This document is a response to the Harmony SP6 Initial Submission Review comments we received on February 3rd, 2023.

Application Number: DA-1925-14

Case Numbers: **2013-7001-07; 2023-6001-00; 2023-4001-00; 2023-3001-00**

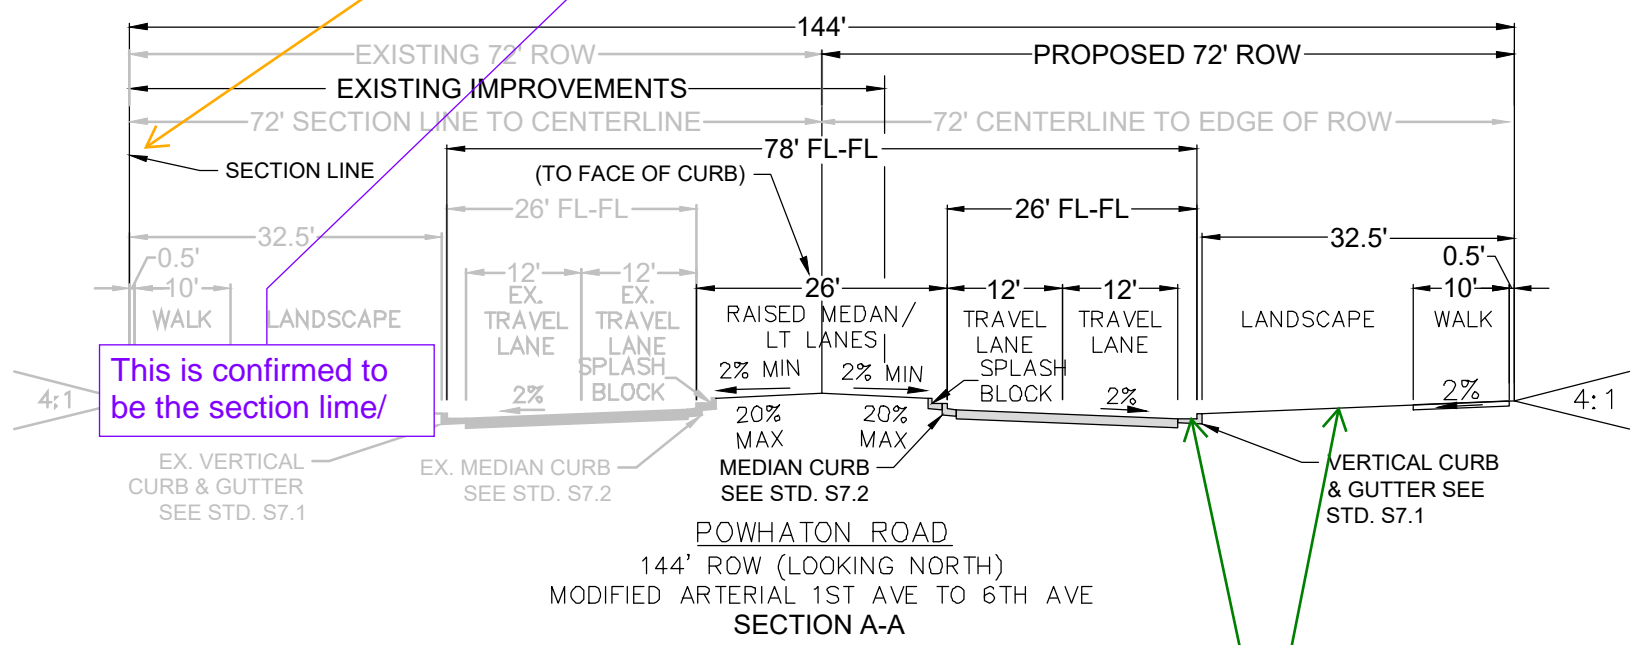
Traffic comments on ROW/Easement plan on need for signing/stripping, and other notes apply here.

Is this the section line? It appears Powhatan south of here has section line running through the SB travel lanes. Confirmation needed.

**Figure-1**  
**Location Map**

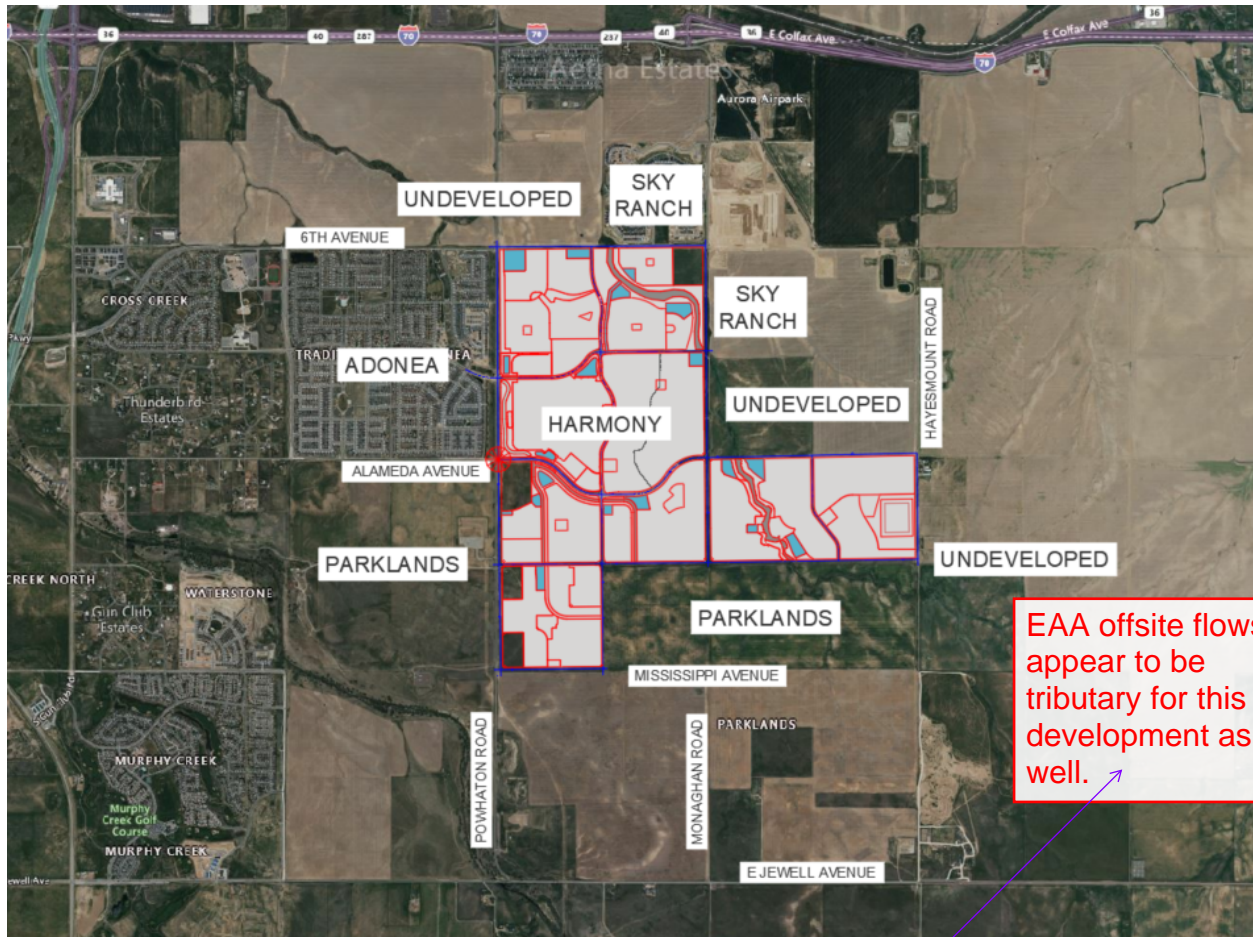
Master documents are at approval and should be referenced in this report

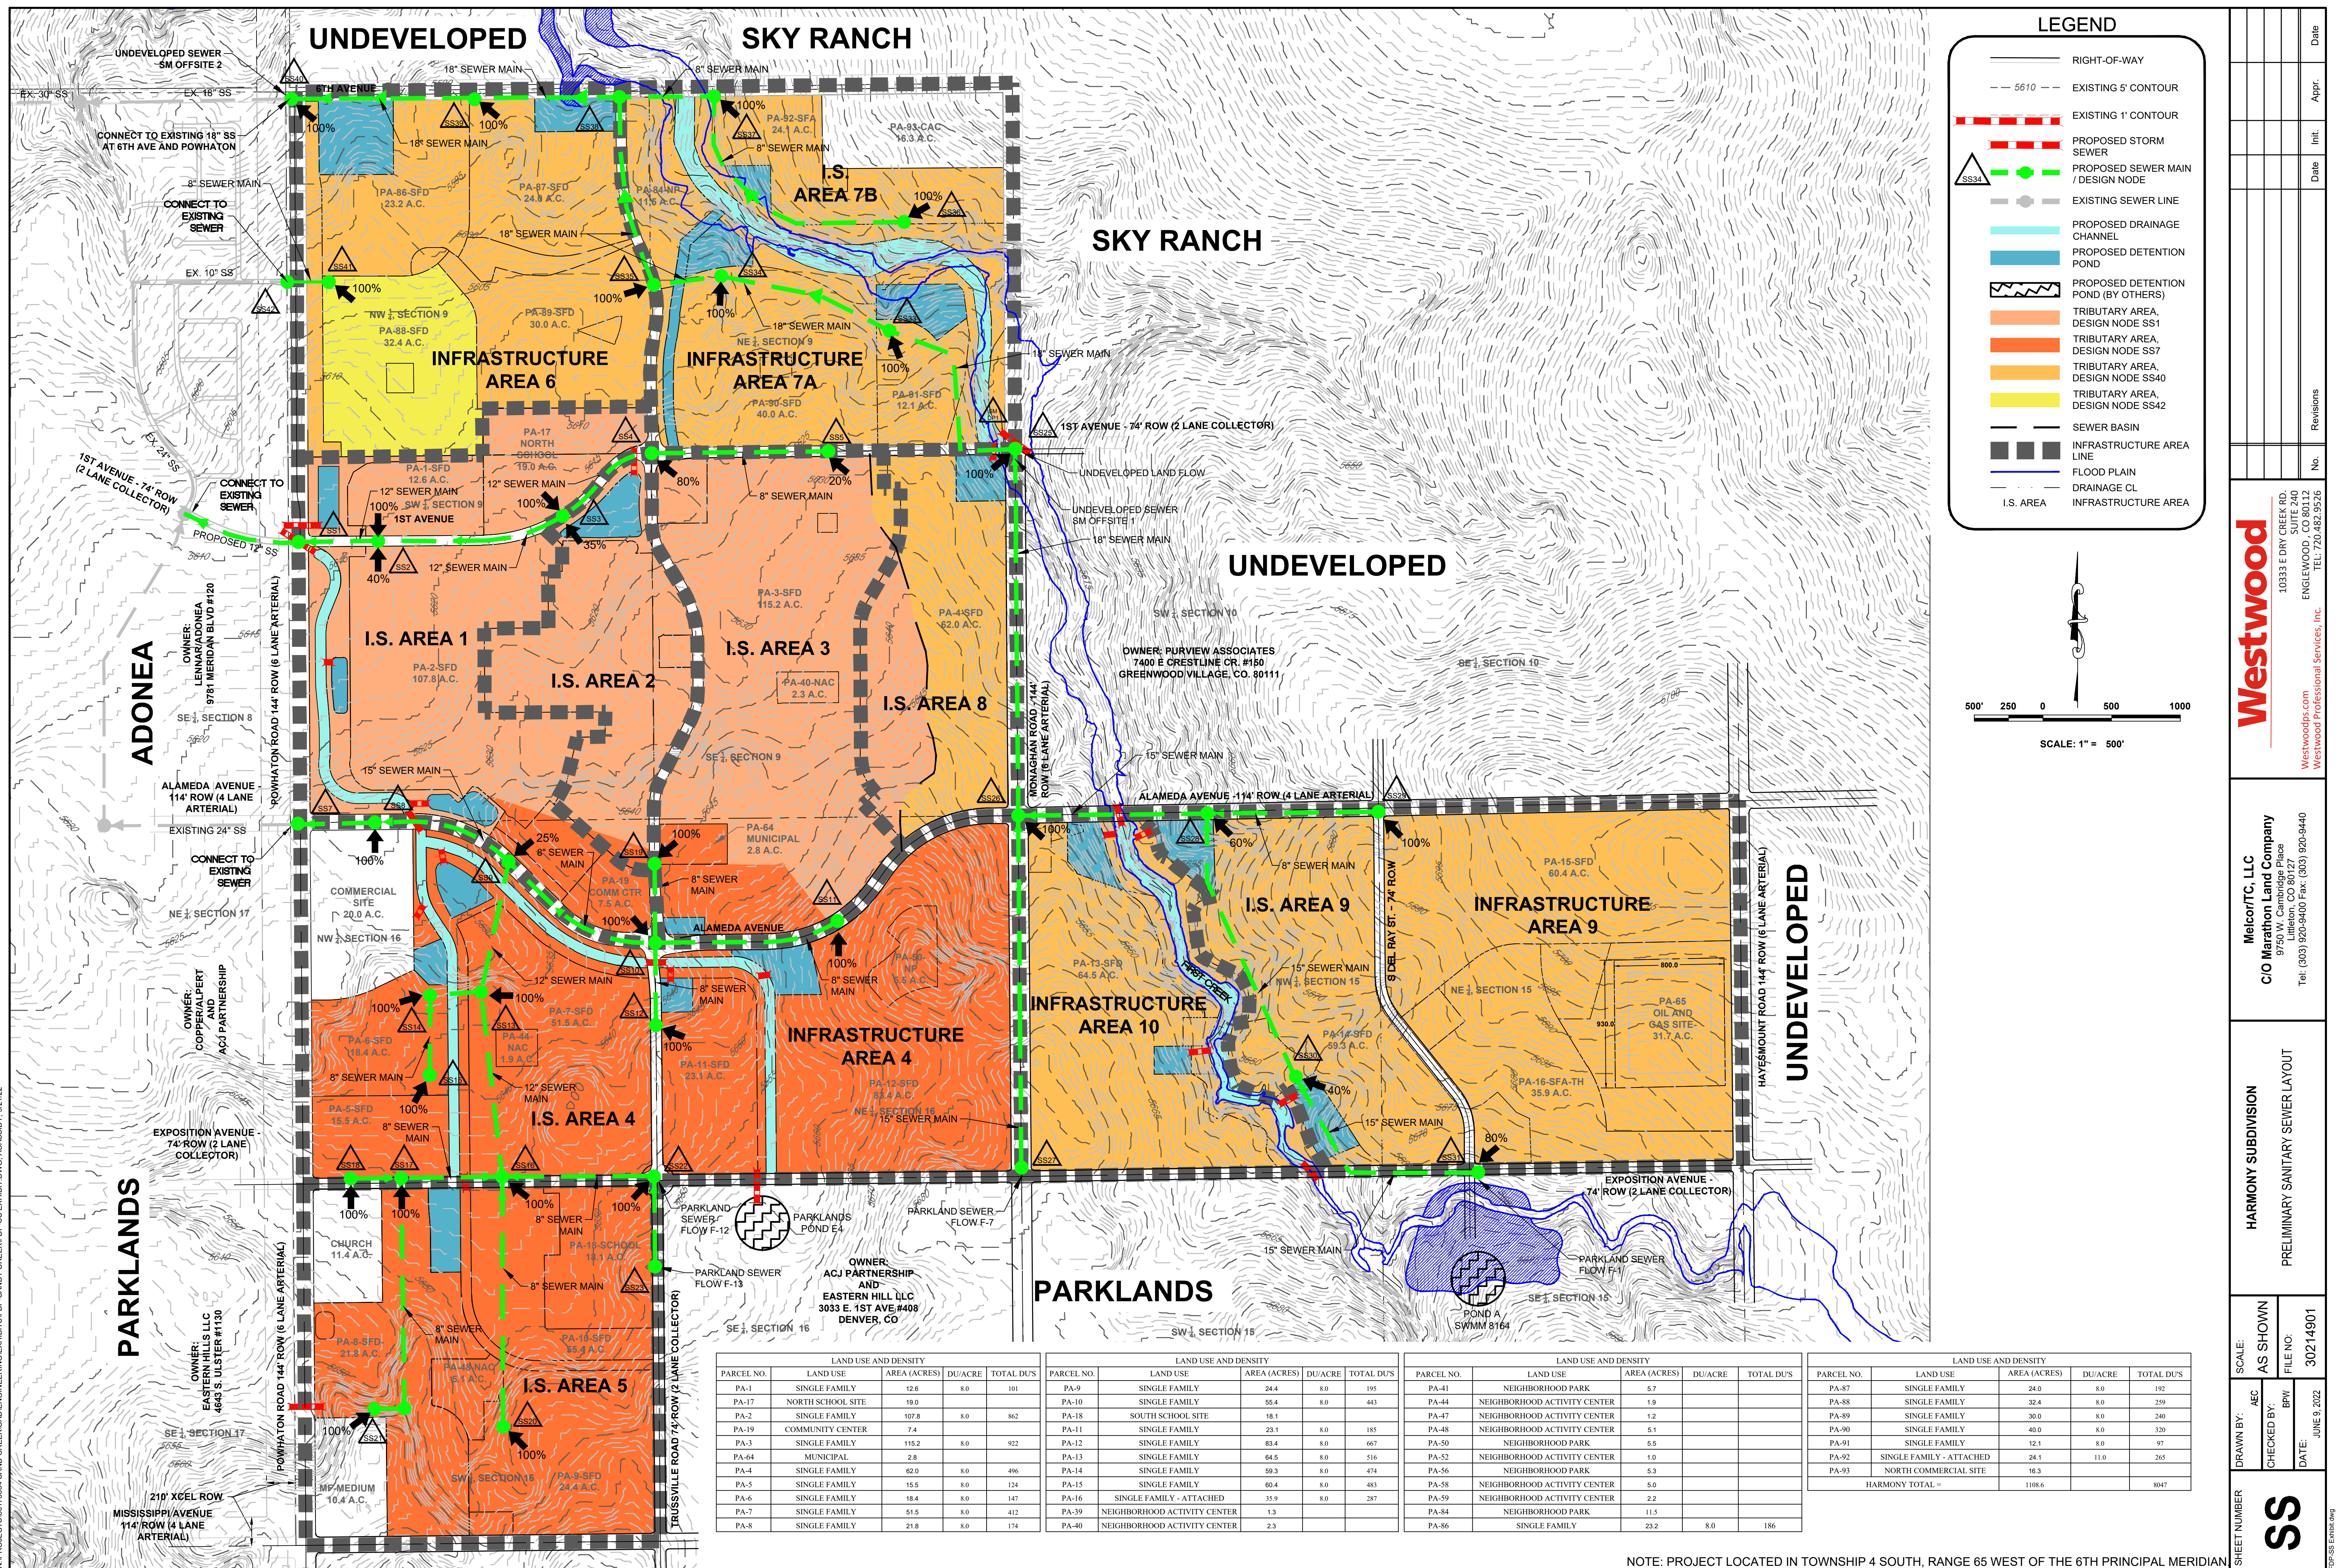
Where is this flow coming from as it is not provided in the Parklands MUS?

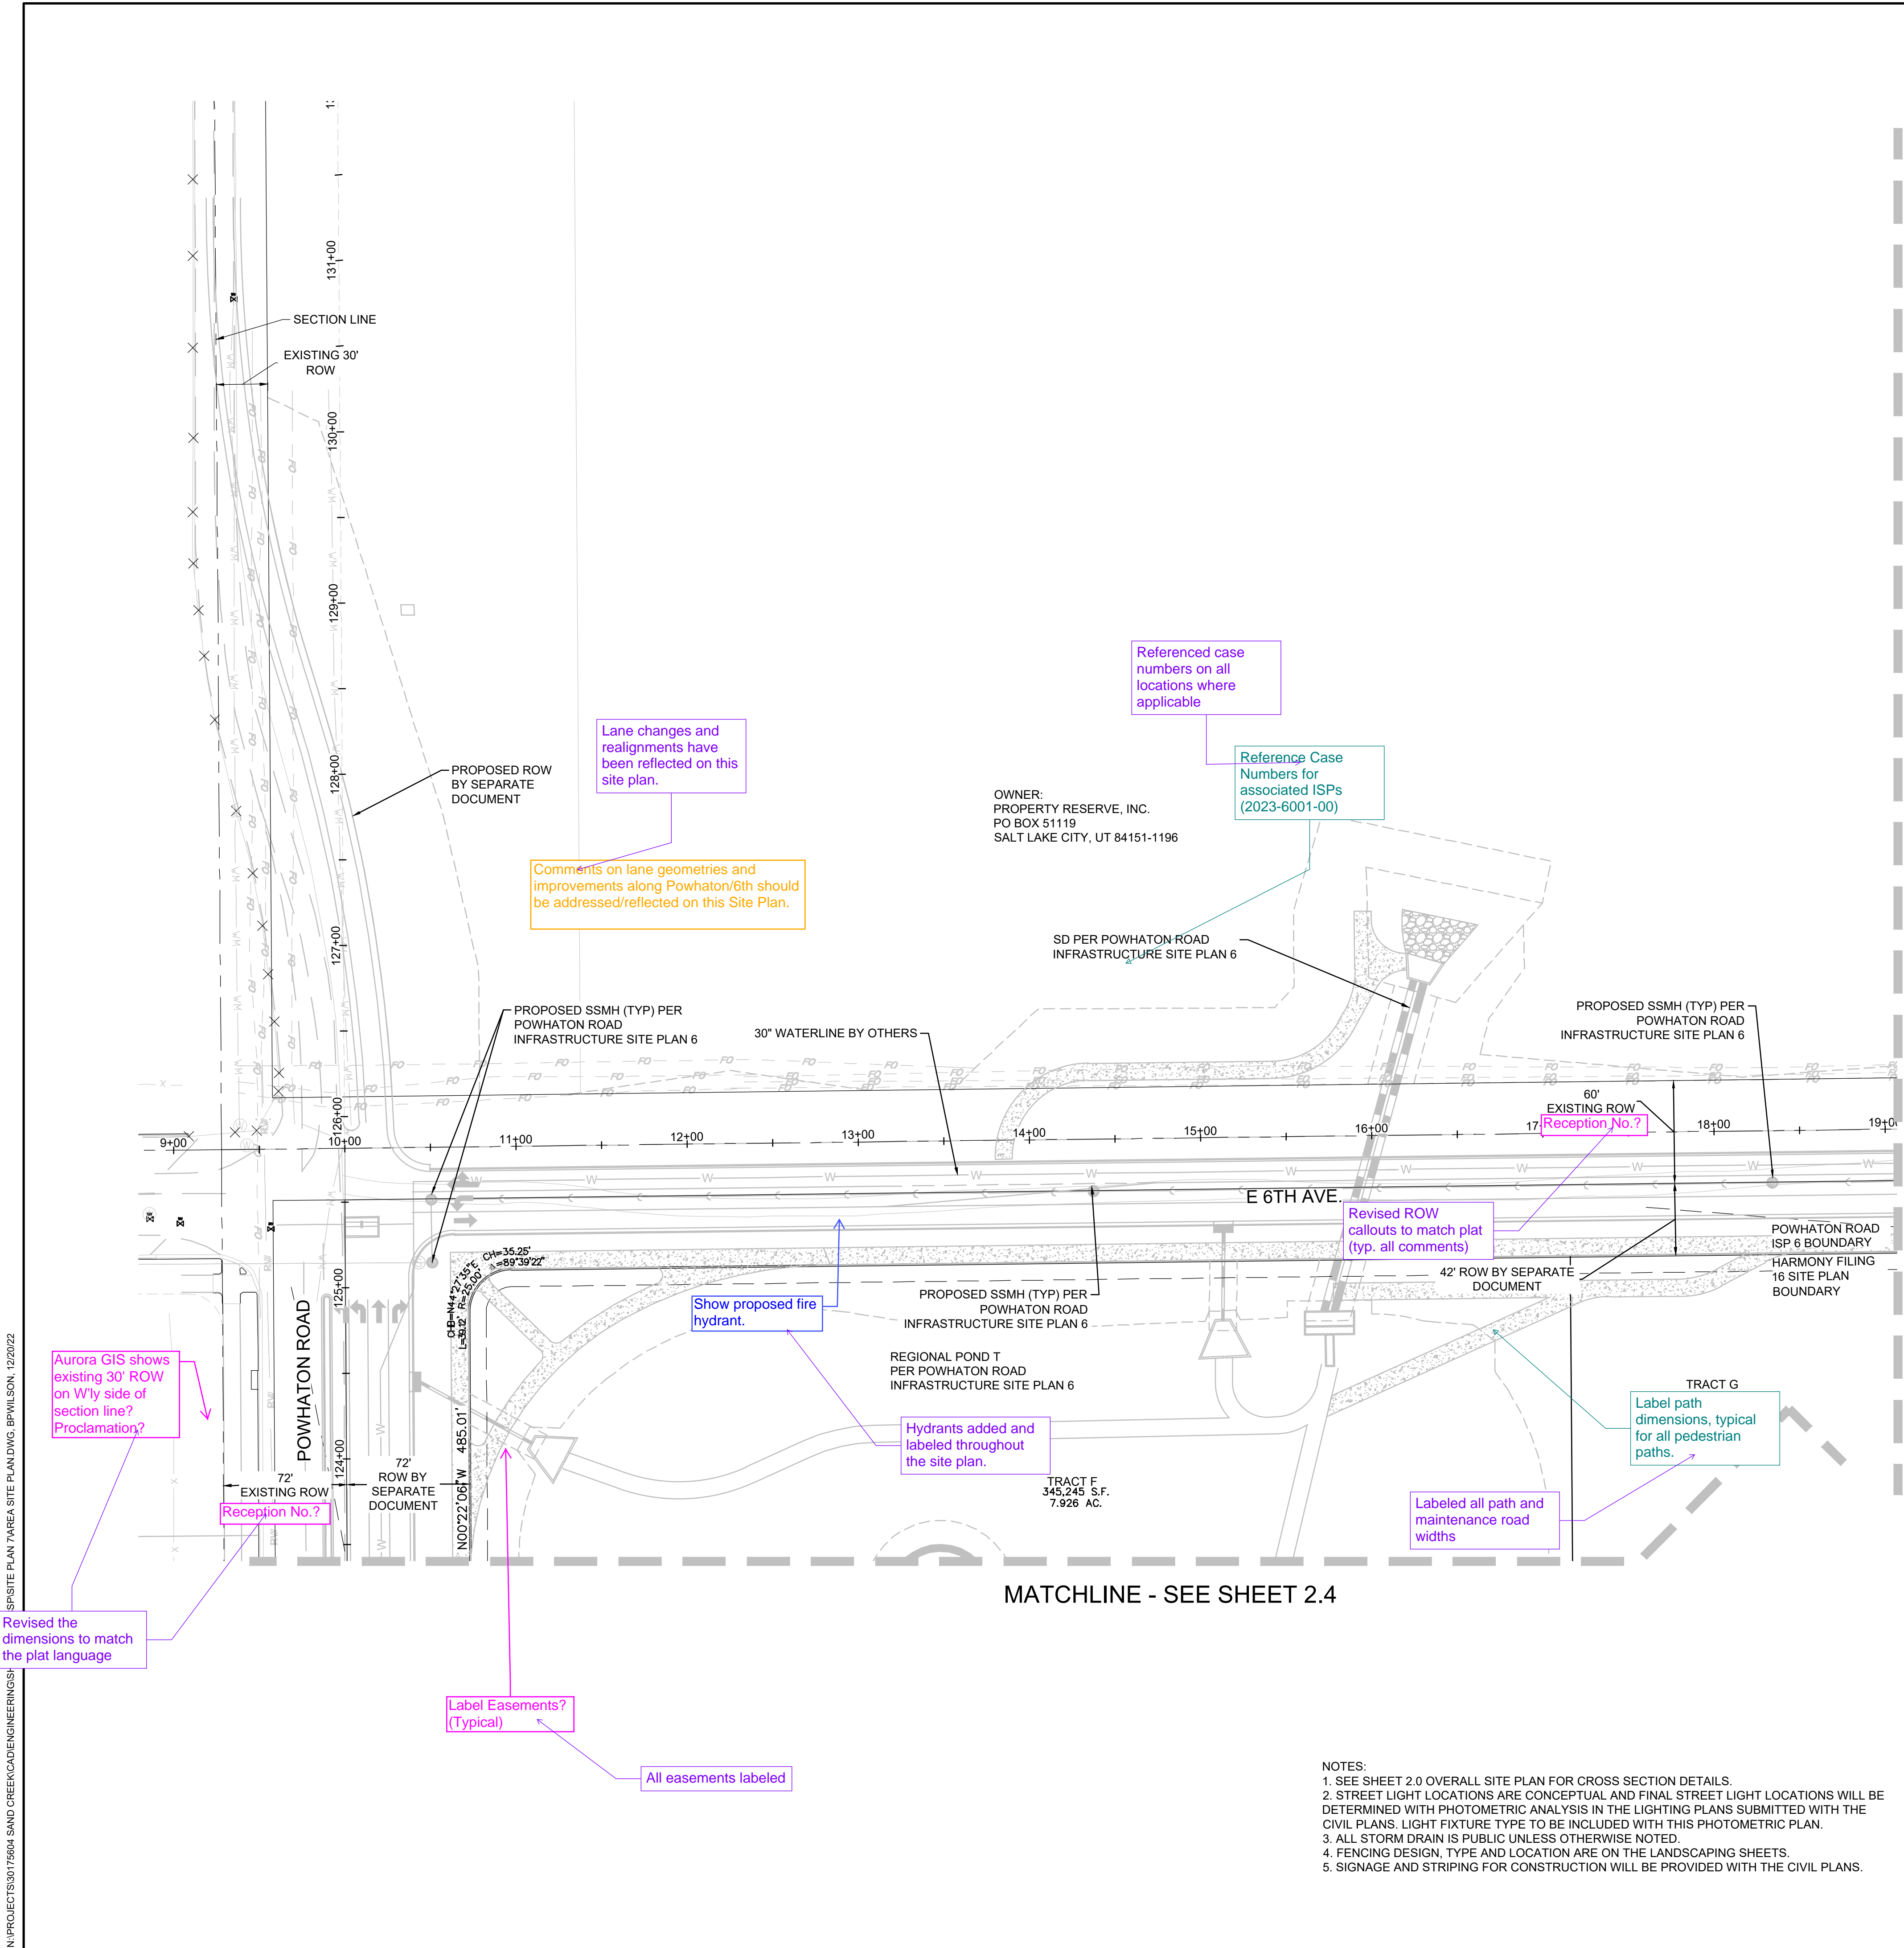
For the purposes of the local destination section (two turn rule) Robertsdale will count as a collector street. All lots are in compliance with the local destination section.
